Subject ▶ Change on O-ring

For Models ▶ 6800DB, 6800DBV, 6801DB, 6801DBV (Drywall Screwdriver)
6802B, 6802BV (Screwdriver)

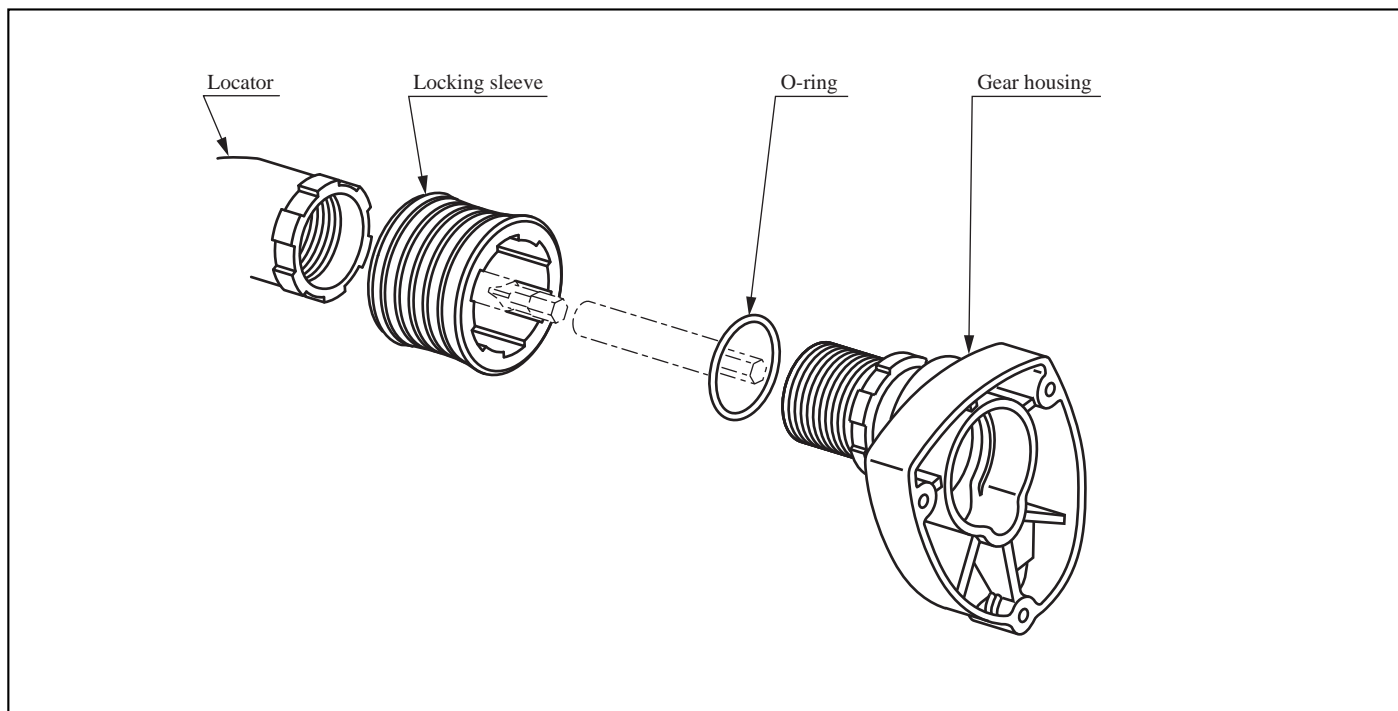
Description ▶ The inner diameter of the O-ring shown in the figure below will be changed from 23 mm (29/32") to 27 mm (1-1/16").

Item No.	Current part		Q'ty	I/C	New part		Q'ty	Note
6	O-ring 23 213363-7		1	Yes	O-ring 27 213404-9		1
